REFERENCE:	Nova Bus Manuals
SECTION:	11 Fuel tank
RS N°:	—
EFFECTIVE IN PROD.:	—

SUBJECT:	60 FT vehicle metallic fuel tank
JUSTIFICATION:	Modifications to the fuel tank warranty

Figure 1 - Fuel Tank

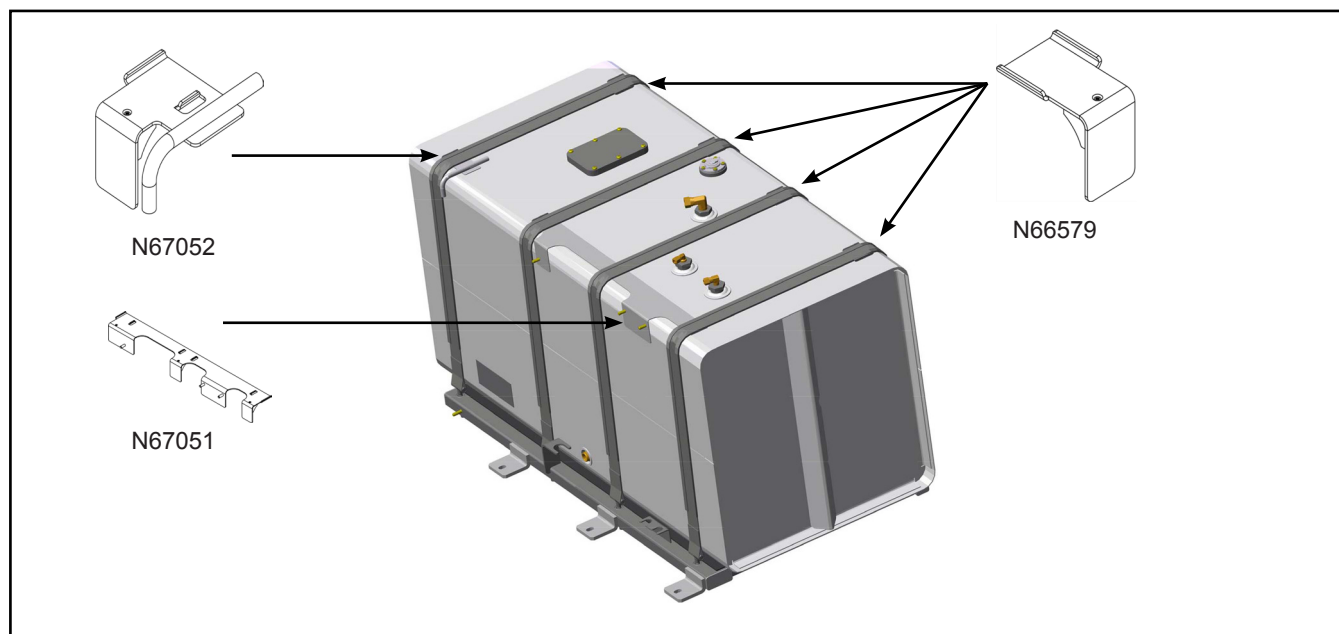
In the case of the fuel tank replacement, N67051 stud plate, the corner supports N67052 and N66579 should be installed under the fuel tank straps. See Figure 1 and the Nova Bus maintenance manual for the replacement procedure.❖
